CHAMBLISS PROPERTIES SUBDIVISION,

UNIT 2

APPLICATION NUMBER 9 DATE December 15, 2005

CHAMBLISS PROPERTIES SUBDIVISION, UNIT TWO

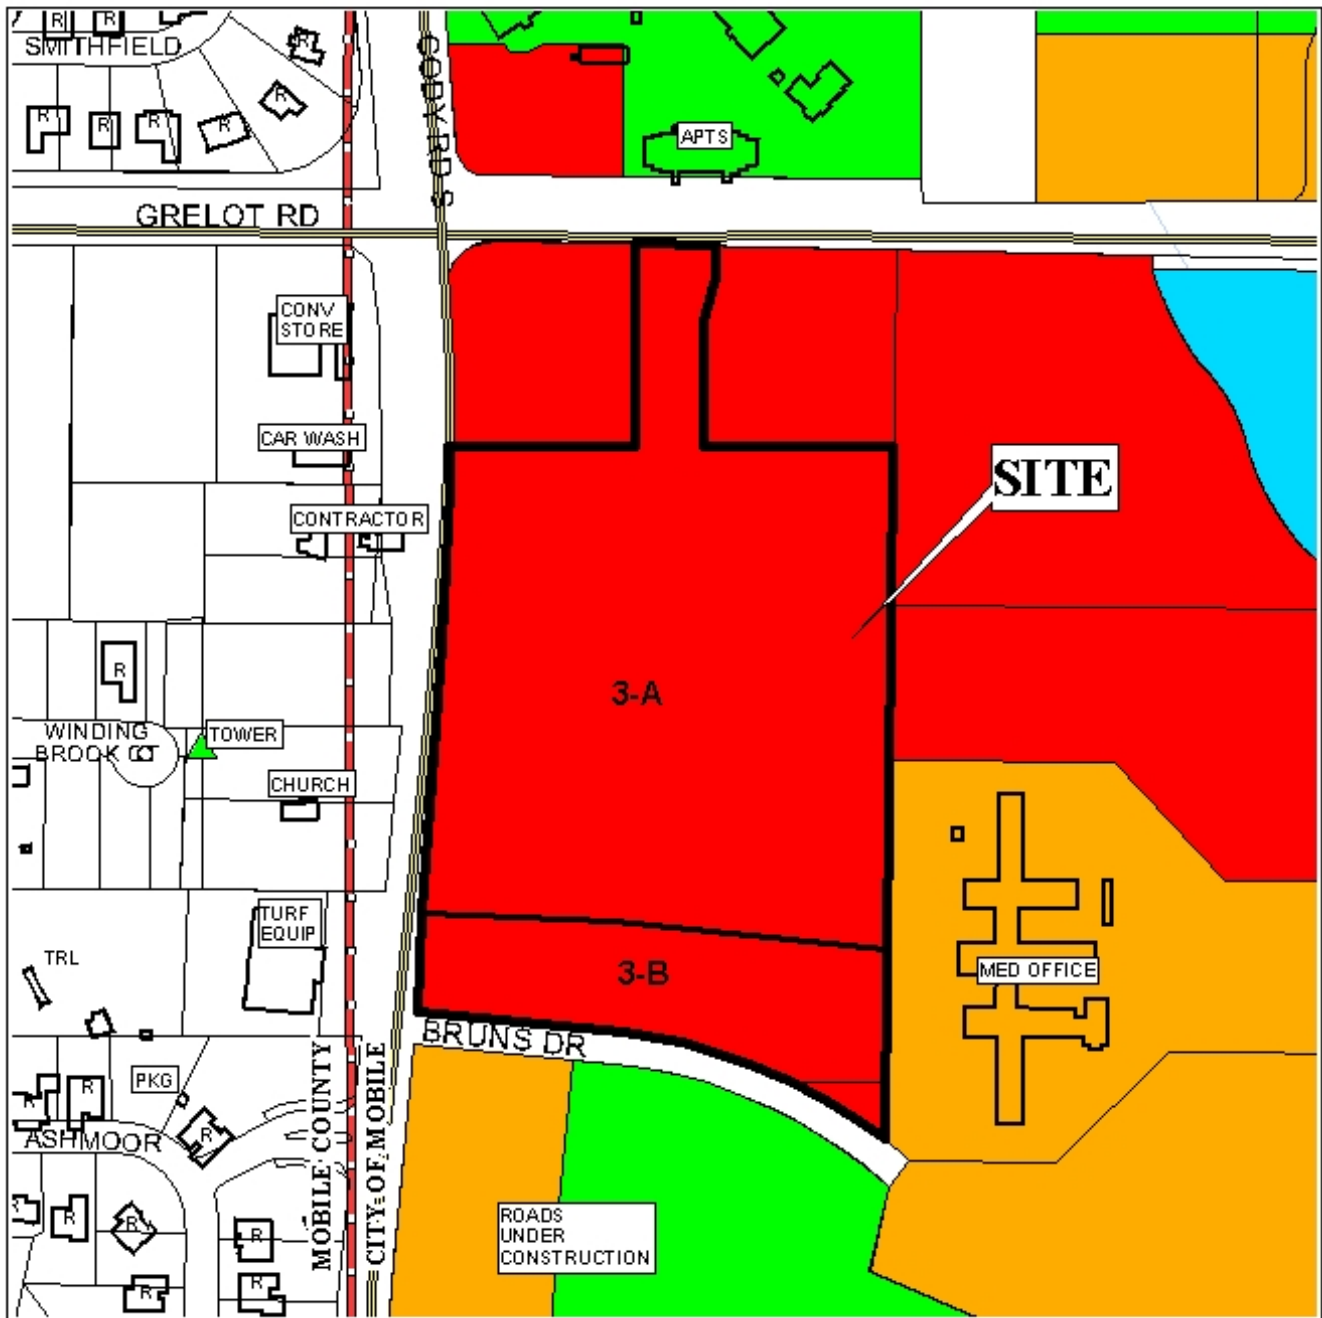
As the site has extensive frontage, including on two major streets, all curb cuts must be coordinated with both Urban Development and Traffic Engineering.

The plat meets the minimum requirements of the Subdivision Regulations and is recommended for Tentative Approval, subject to the following condition: 1) coordination with and approval by both Urban Development and Traffic Engineering for the location, number, and design of all curb cuts.
